-	12489 & 12861 Dixie Rd.	Date	
Address:			
Project			21 April, 2025
Description:			
File	D7 2024 0024 and D0D4 2024 0044		
riie	RZ 2024-0034 and POPA 2024-0011

traffic.		findings and recommendation will be provided as part of a subsequent submission.
Proposed Official Plan Amend	ment and Zoning Bylaw	Amendment Applications
Town of Caledon, Development and Design – April 15, 2025		
1 Planning Justification Report

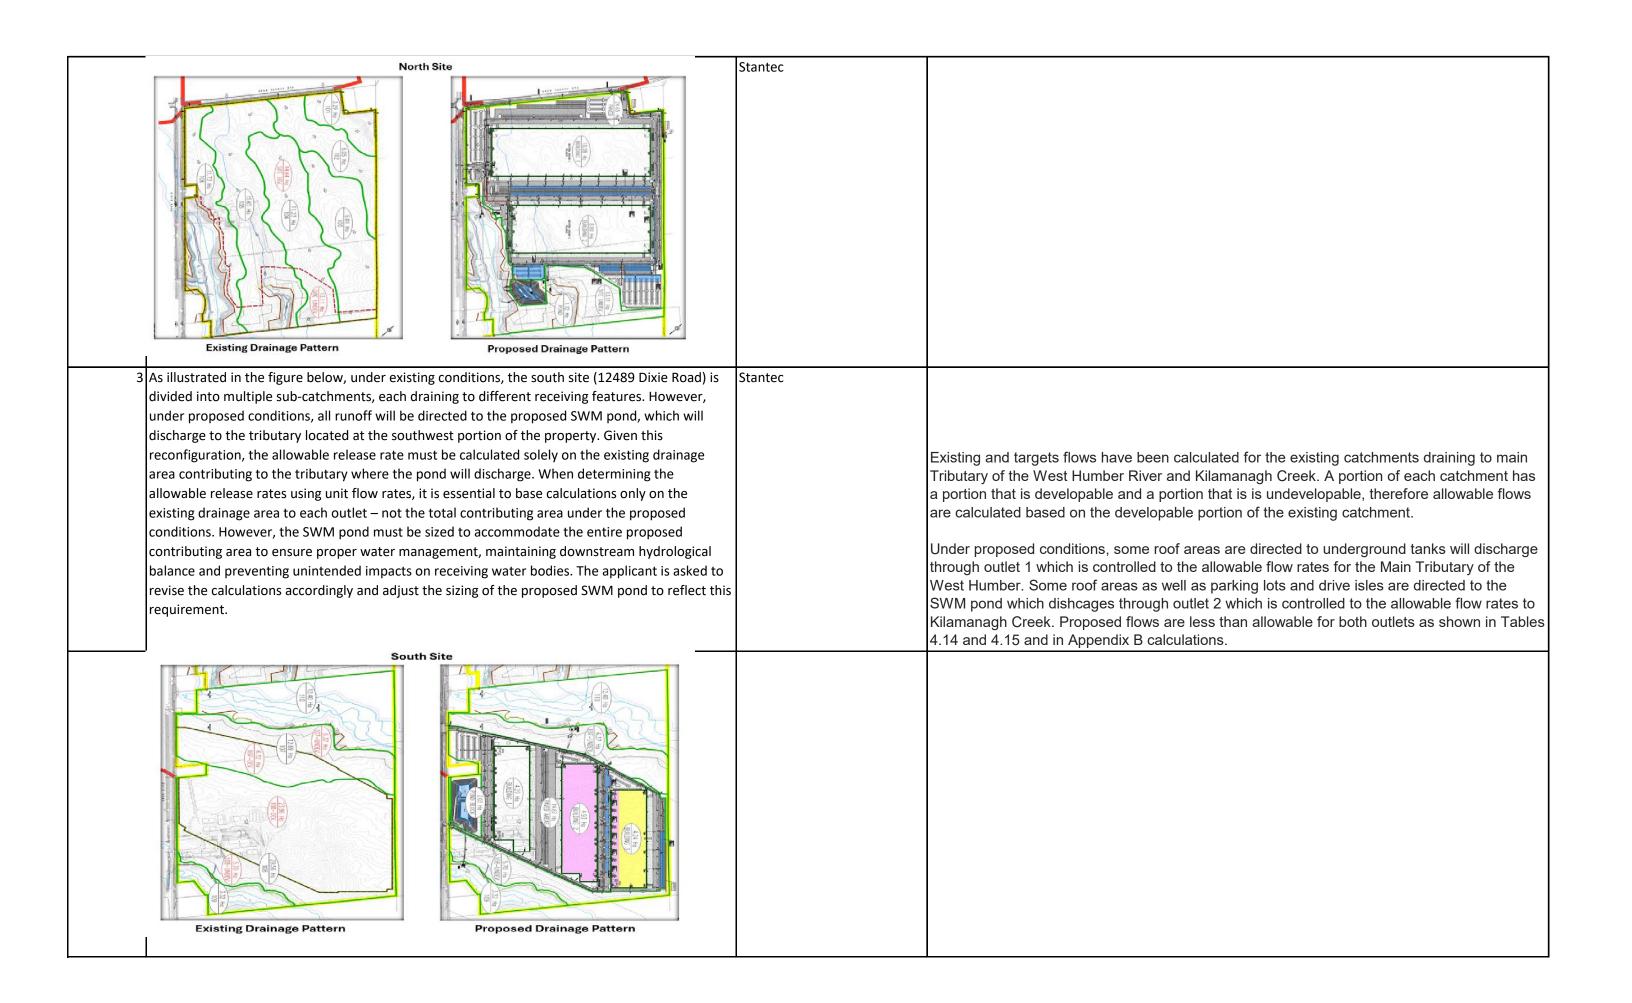
• South Side SWM Pond – Please show location and elevation of emergency spillway.	Stantec	Emergency overflow is directed over private driveway and will sheet flow towards Kilamanagh Creek.
Assuming that spillway is on the South side and ultimately flows to Kilamanagh		Spillway is adequately sized to ensure drainage is not directed to Dixie Road.
Creek, how is the flow being directed over the private drive to the right of the pond,		
as well as routed overland to the Creek since there is a considerable distance (~135		
 m)? The Region will not accept emergency overflow onto the ROW of Dixie Road.		
 Legal Requirements
